APPROVED AMITY COLLEGE SCHOOL PROJECT SSD-9227

PT. LOTS 1 & 2 DP 525996 No. 85 BYRON ROAD & No. 63 INGLEBURN ROAD,
LEPPINGTON, NSW

s.4.55(2) Modification Application Report: SSD 9227 MOD 1

Proposed Accelerated Staging of Project

Figure 3.2 (below): Proposed Revised Stage 1 SSD 9227 MOD 1

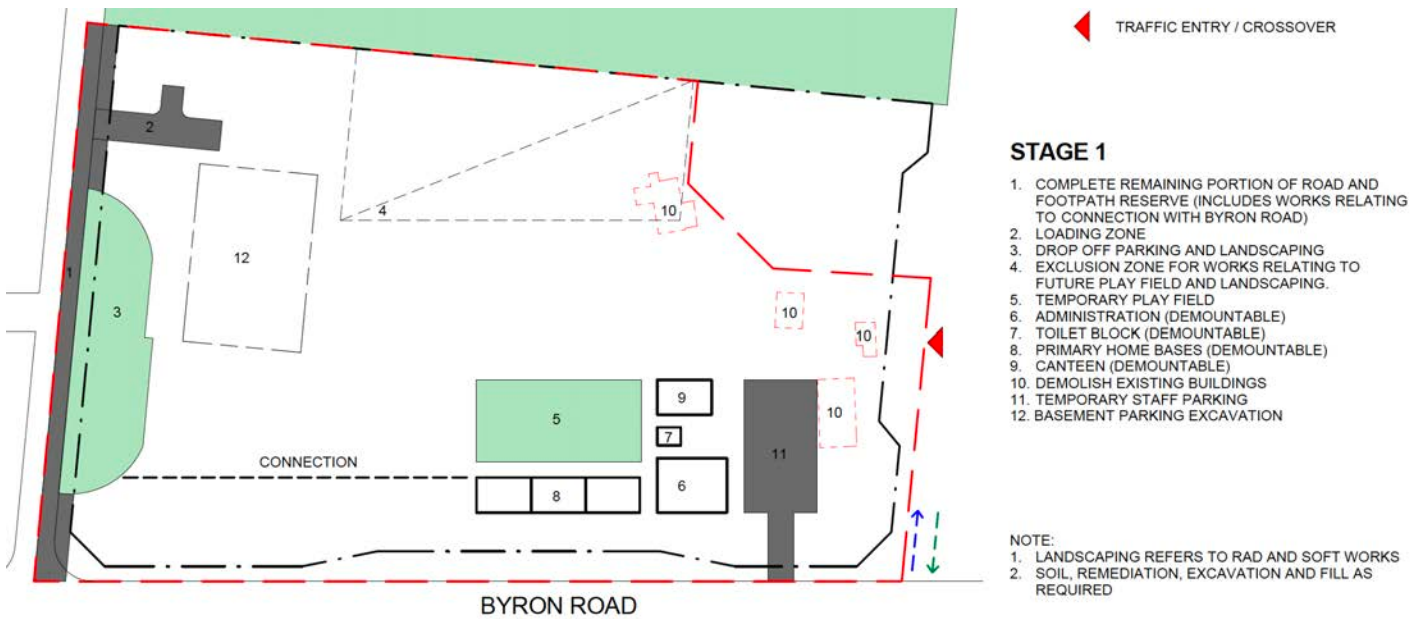
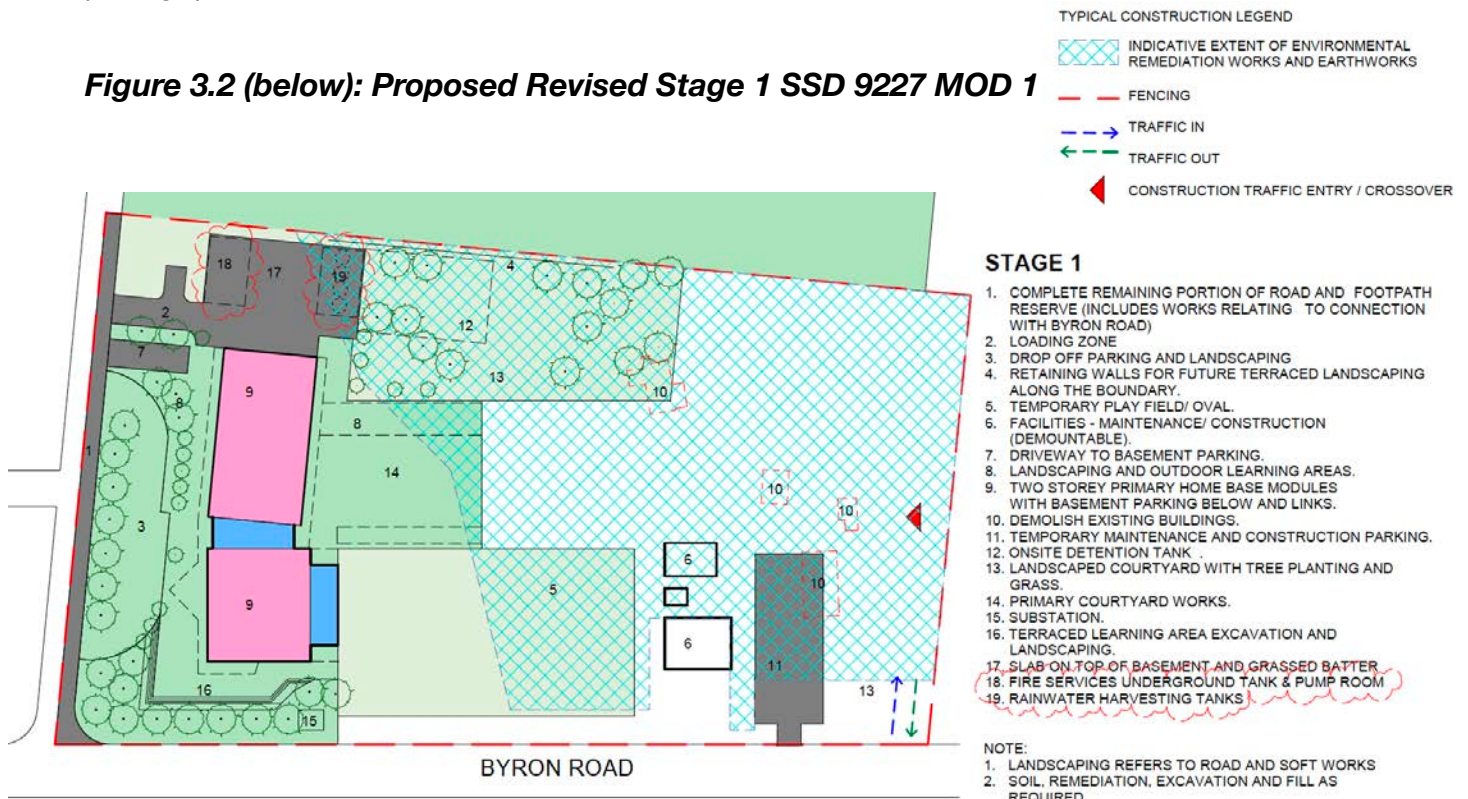
The currently approved Stage 1 provides for a school accommodating up to **75 students** in **temporary** school buildings with **17 permanent car parking spaces** (on site pick up/drop off) and 10 temporary parking spaces.

The proposed Stage 1 provides for a school accommodating up to **300 students** in **permanent** school buildings with **62 permanent car parking spaces** (17 on site pick up/drop off spaces + 45 basement car parking spaces) + 10 temporary parking spaces (maintenance and construction parking). Site remediation works have involved clearing and excavation works over the site, shown cross-hatched on the figure above.

FIGURE 3.15: Proposed revised Stage 1 sediment & erosion control SSD 9227 MOD 1
 (Source: Martens & Associates, consulting engineers)

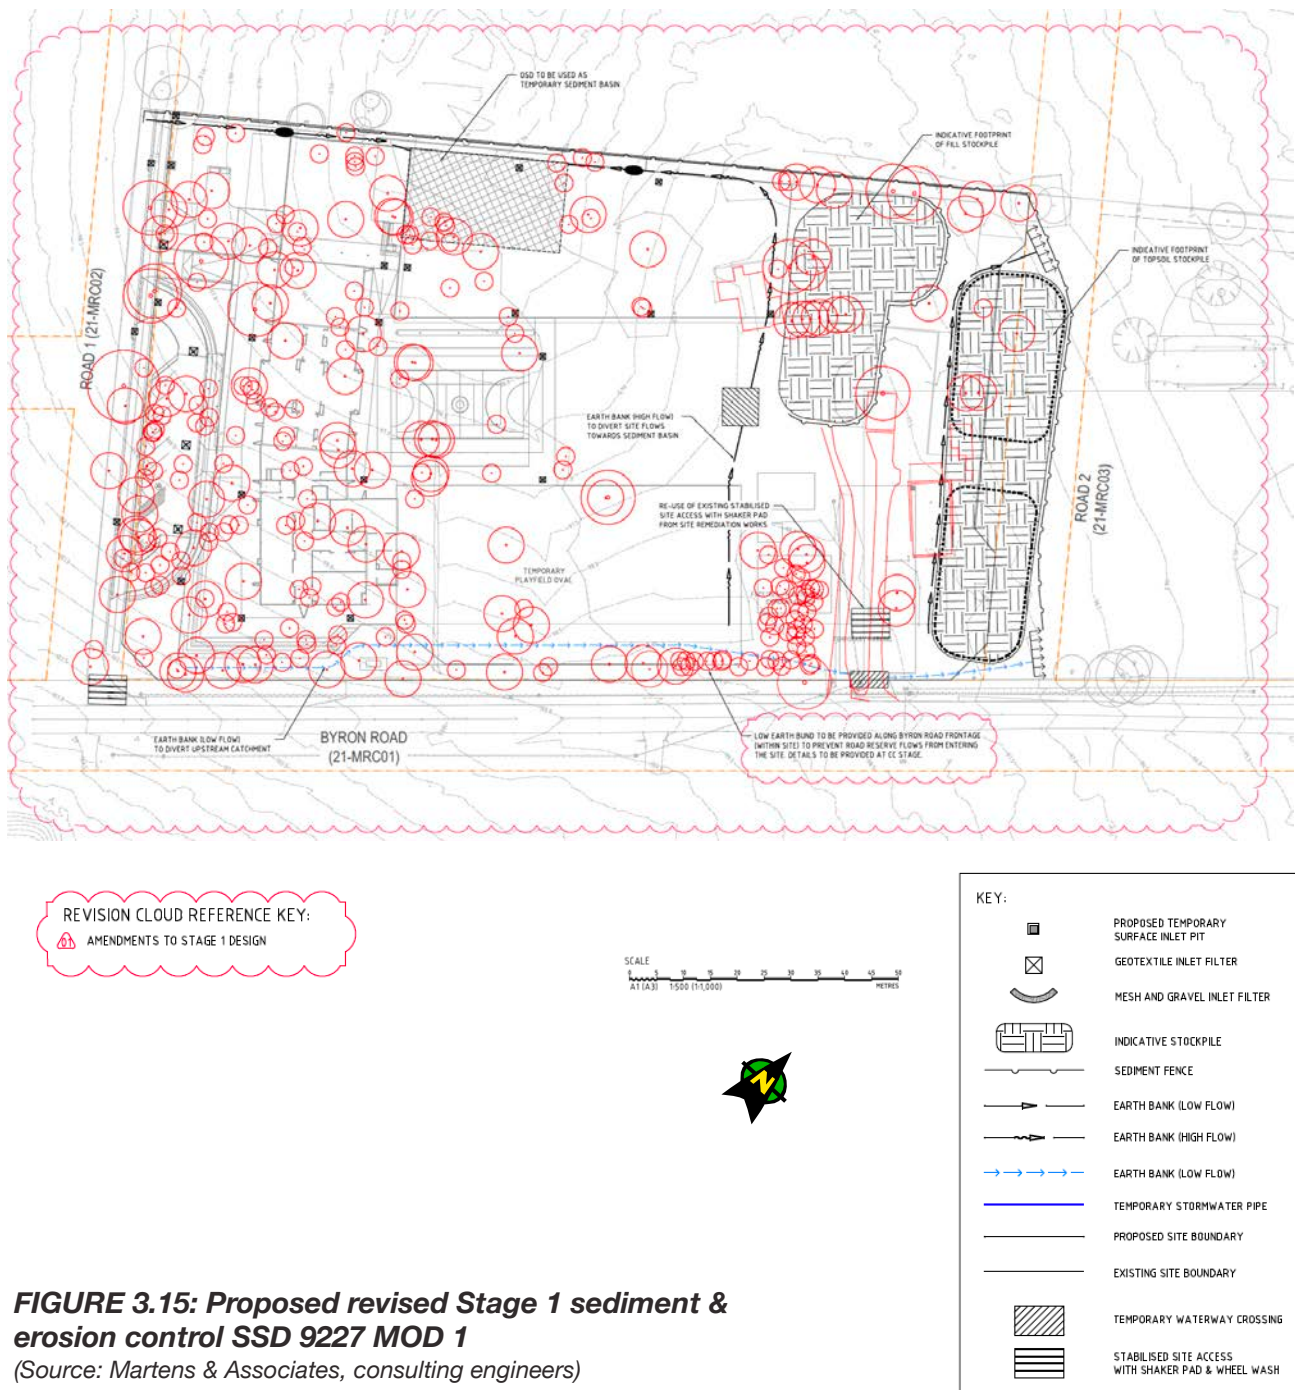
- The Stage 1 works area, including extent of sediment and erosion control works, reflects the accelerated staging proposed- refer PS08-B100 and PS08-B301. The plans show the area subject to remediation undertaken to date, with stockpiles shown as part of the sediment and erosion control plan and stormwater plans for revised Stage 1. OSD used for sediment basin in Stage 1 in lieu of open sediment basin as originally proposed.

FIGURE 3.16: Proposed revised Stage 1 earthworks plan SSD 9227 MOD 1
(Source: Martens & Associates, consulting engineers)

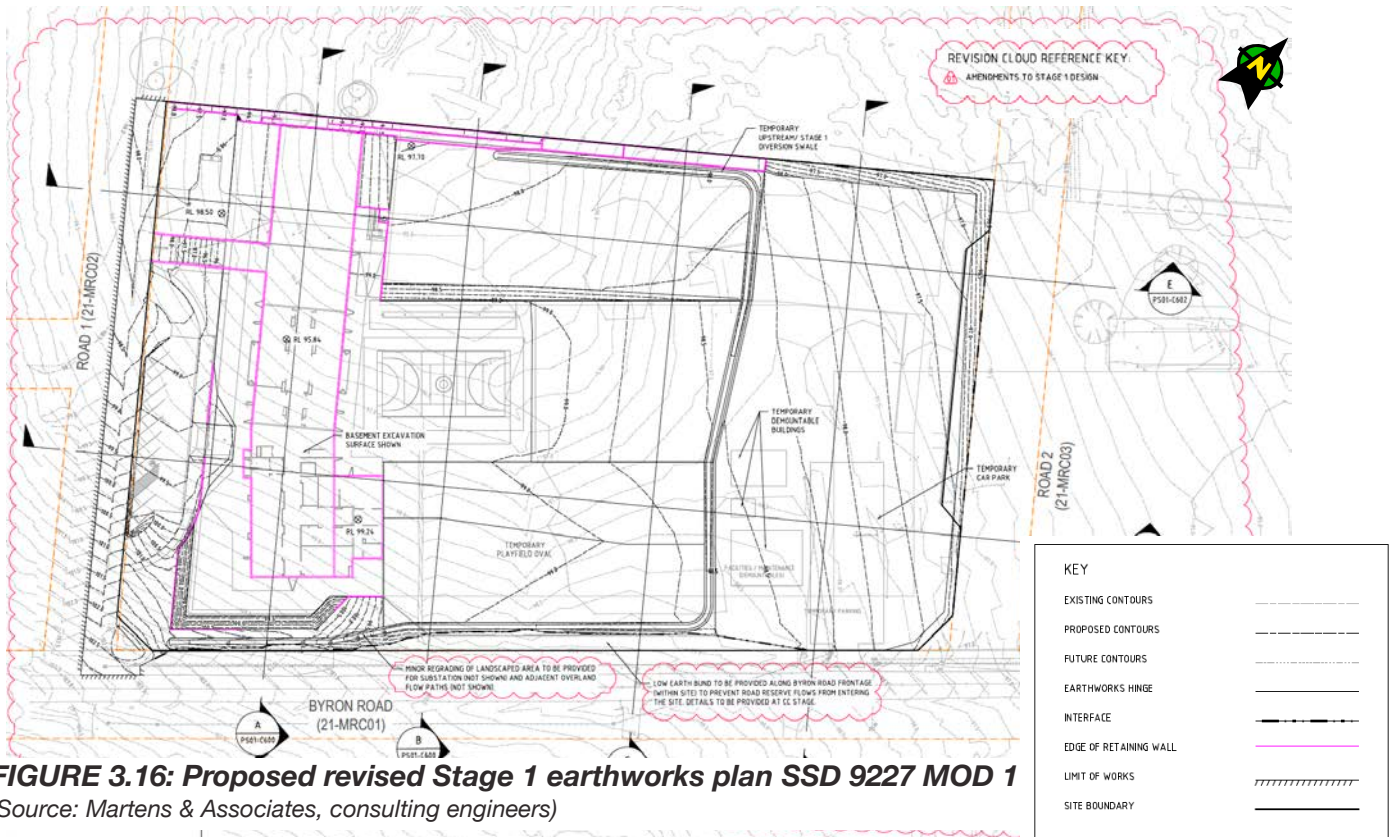
- The revised Stage 1 bulk earthworks and grading plan reflects the accelerated staging proposed and remediation works undertaken - refer PS08-C100-C501. Earthworks details upgraded for ultimate stage to reflect the Stage 1 works- refer PS08-C501-C603. Ultimate cut and fill almost identical to that approved, with an additional allowance for additional fill to replace contaminated fill removed from the site- refer PS08-C500.

FIGURE 3.20 (above): Revised 1st Floor of Primary School compared to original approved DA plan. Minor changes changes

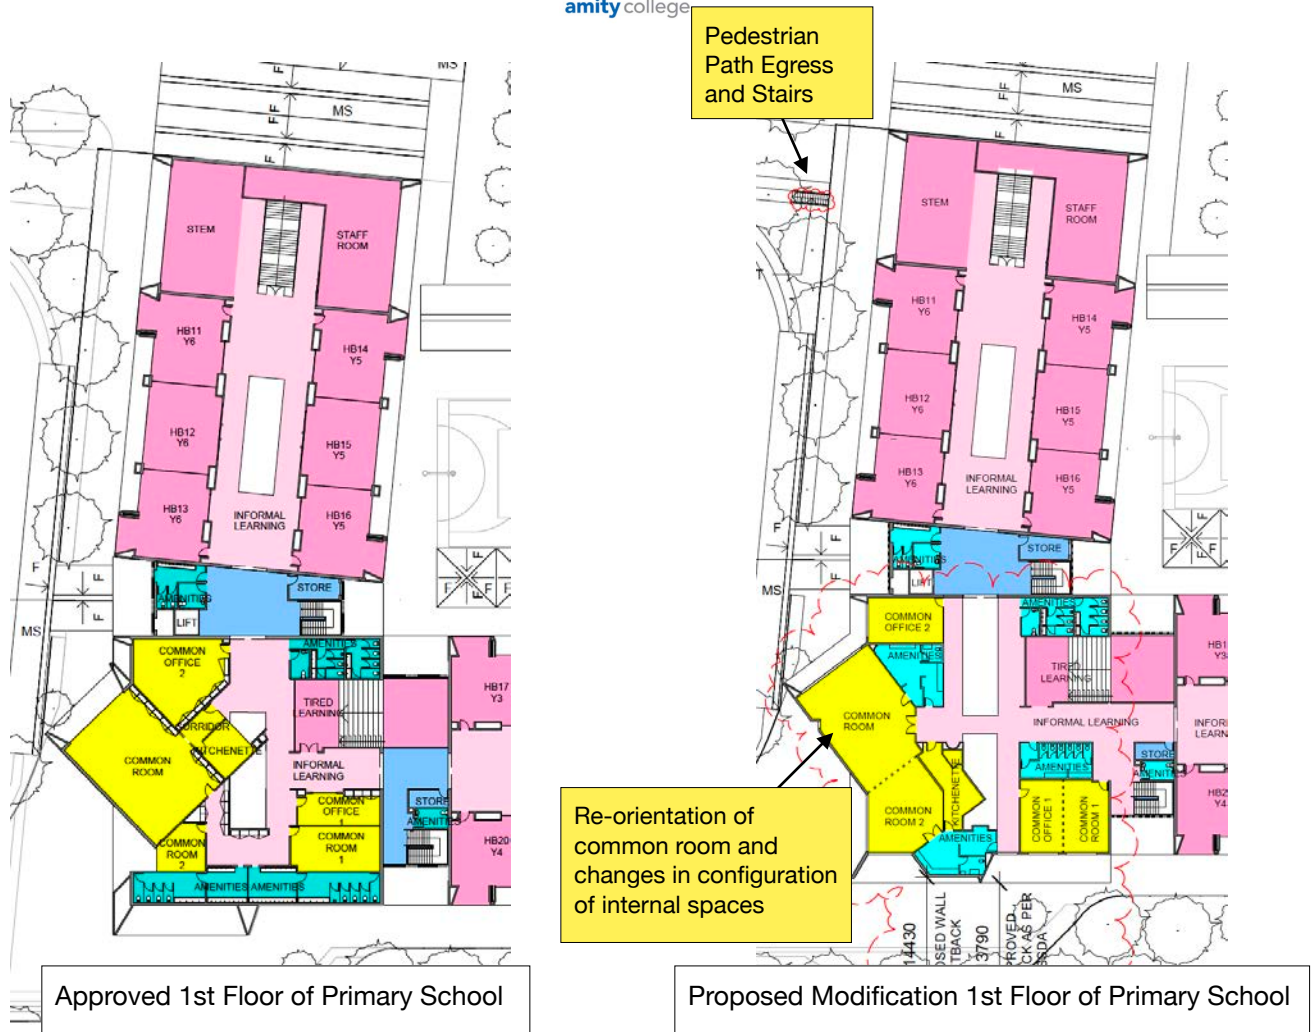
- Minor changes have been made to the configuration of classrooms and internal spaces, necessitating minor changes to the building form, orientation and floor space on the 1st floor. An amenities building has been relocated to the Byron Road frontage from the Pluto Avenue frontage, with no resultant encroachment of the approved building setback. These changes are proposed to involve an additional 29m² of floor space. Refer **Figure 3.20**.

- ▶ Slight reorientation of School Common Room to the west. This results in changes to all school rooms in the vicinity. Refer to Figure 3.19 comparing the “before” and “after” effects of this proposed change to the layout and orientation of this part of the Primary School.

- ▶ Amenities room projects marginally further from building, but still is within the approved building setback in this part of the school. [NOTES: 1. The approved plan allows a southern projection of the building footprint to accommodate an amenities section. This projection has been removed under the modification. 2. Net increase in amenities provided, principally for female staff, and in accordance with BCA requirements]

FIGURE 3.21 (left): Revised facade Byron Road frontage of Primary School. Larger windows and less blank walls provided- a visual improvement.
(Source: Gran Associates Australia, architects)

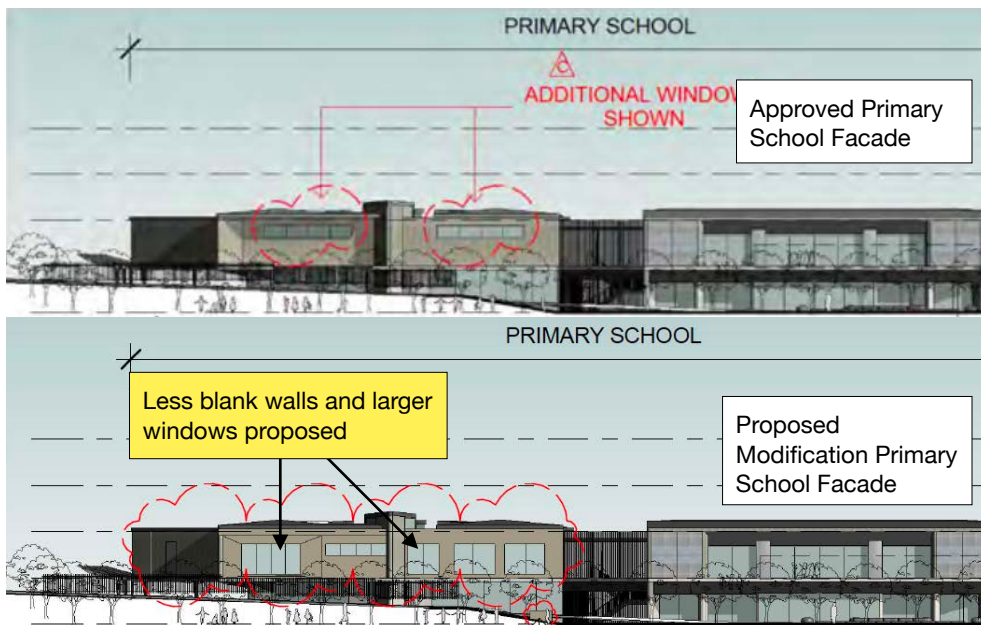
- The facade of the Primary School building facing Byron Road has been improved with the inclusion of larger windows, providing additional visual relief when viewed from Byron Road- refer **Figure 3.21**.

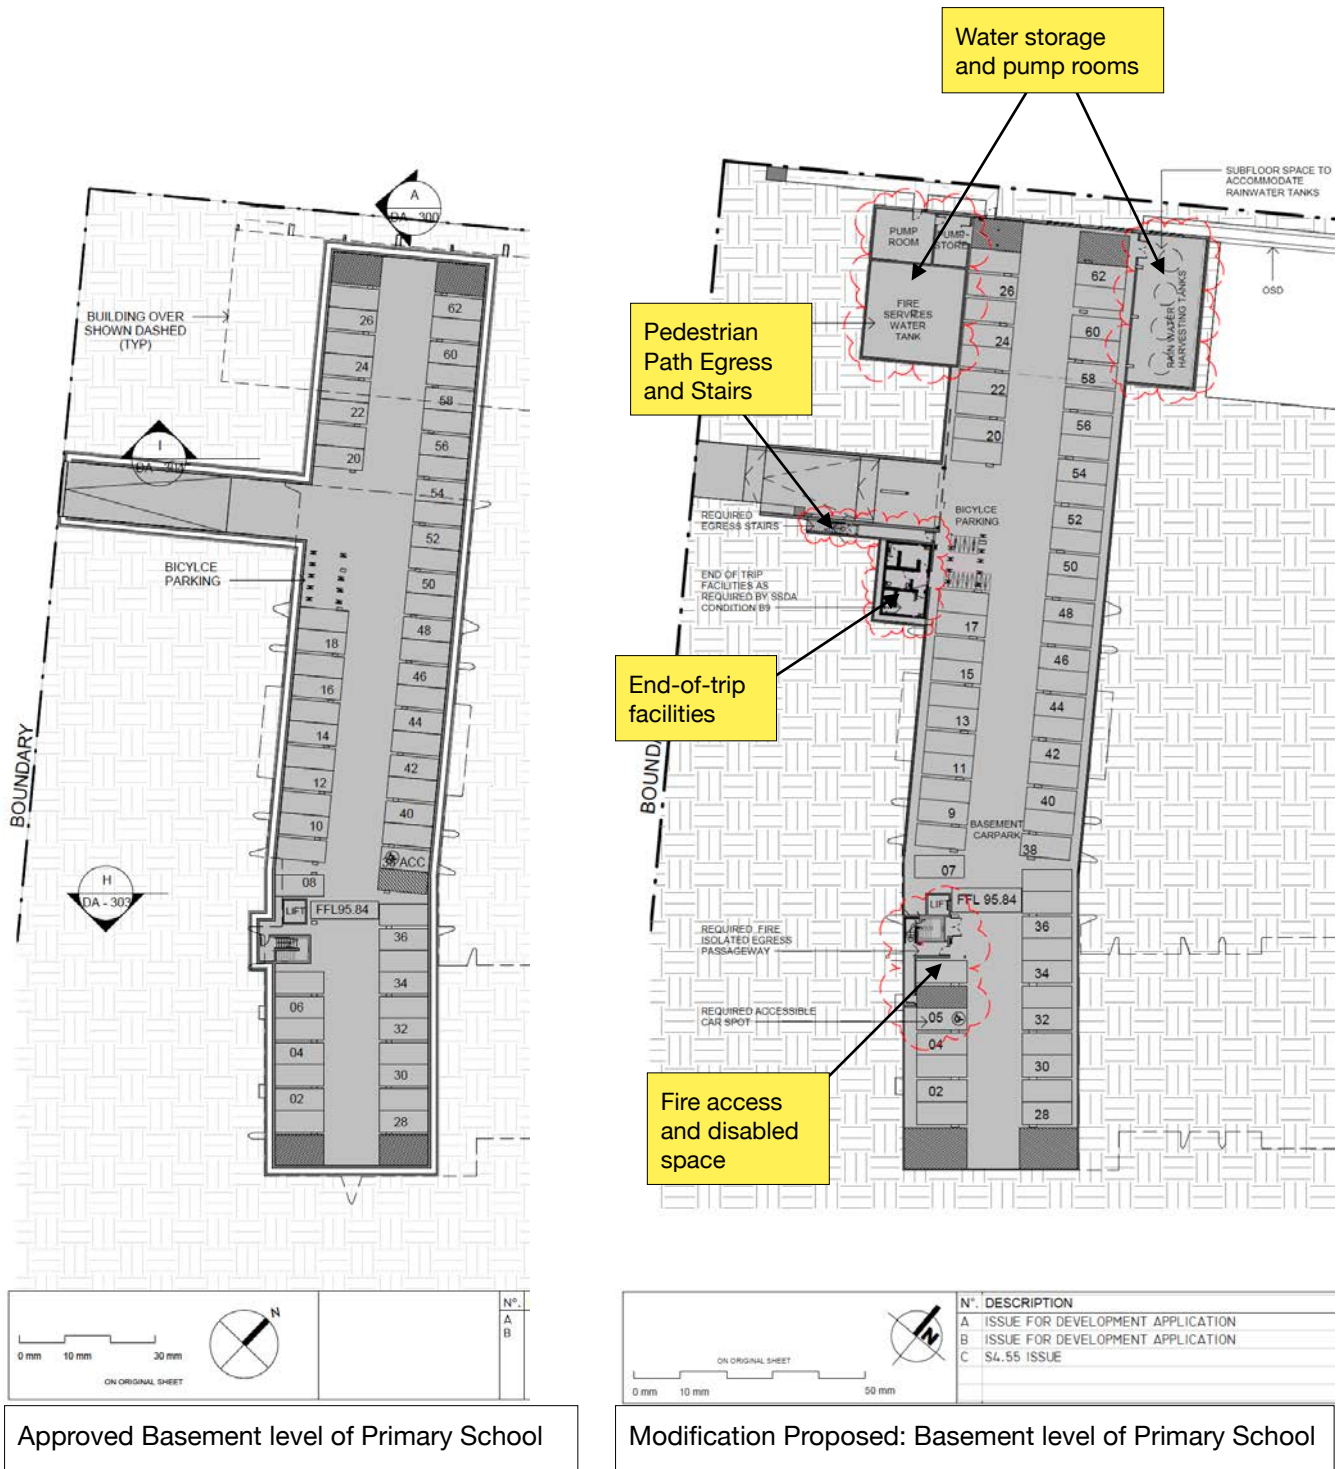
- The architects drawings also provide for an additional space devoted to access, stairwells, and end-of-trip facilities in the basement car park as required by the Condition B9 of consent (refer **Figure 3.22**).

- In addition to the above, the modification seeks approval for additional below ground water storage, as required by Condition B10 and C20 of the consent, and a relocated substation proximate to the Primary School building. Refer to drawings accompanying and forming a part of this modification application. [NOTE: Pursuant to the provisions of clause 42 of *State Environmental Planning Policy Infrastructure 2007* substations do not require development consent. The substation has been shown in the modified application drawings for administrative convenience.] Refer **Figure 3.22**.

- ▶ Path and stairs down to Primary School basement car park, as required by BCA access requirements and SSD 9227 consent Condition B9(g).
- ▶ Provision for end-of-trip facilities, as required by SSD consent Condition B9(e).
- ▶ Provision for fire isolated egress passageway, as required by the BCA.
- ▶ Provision for accessible parking spot per the Australian Standard.
- ▶ Provision for pump rooms and water storage for fire services water and for rainwater harvesting tanks- the latter previously shown in the approved plans at ground level, as required by Condition B10 and C20.
